CITY OF CAMBRIDGE

Re: Special Permit **PB-315 Amendment 2, MXD Infill Development Concept Plan (IDCP)**

Zoning Report: **PB-315 Amendment 2, MXD Infill Development Concept Plan (IDCP)**

Urban Design Report: **PB-315 Amendment 2, MXD Infill Development Concept Plan (IDCP)**

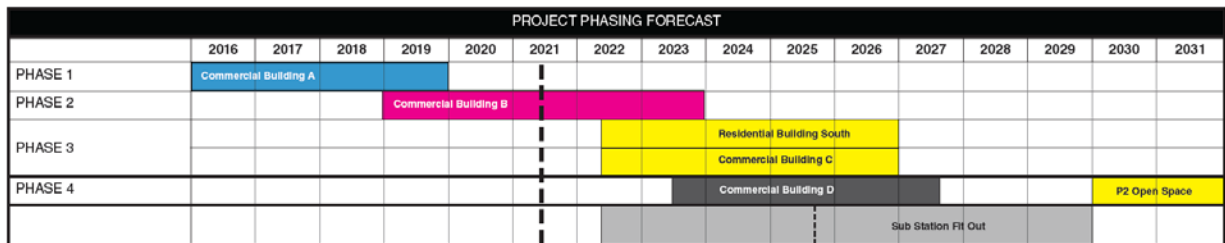
In further analyzing this open space, staff would highlight a few elements the Planning Board could consider should the project proceed:

- Section 14.21.1 of the CZO requires that Public Open Space be guaranteed through a legal mechanism to ensure its perpetual reservation for public use. The actual legal mechanism and timing has not been specified in the Development Plan, but a condition could be included that the mechanism be identified and submitted to the City at the time of Design Review for the Center Plaza. The existing public use covenants for the existing Public Open Space on the south (Broadway) and north (Galileo) sides of the Blue Garage will also need to be modified.
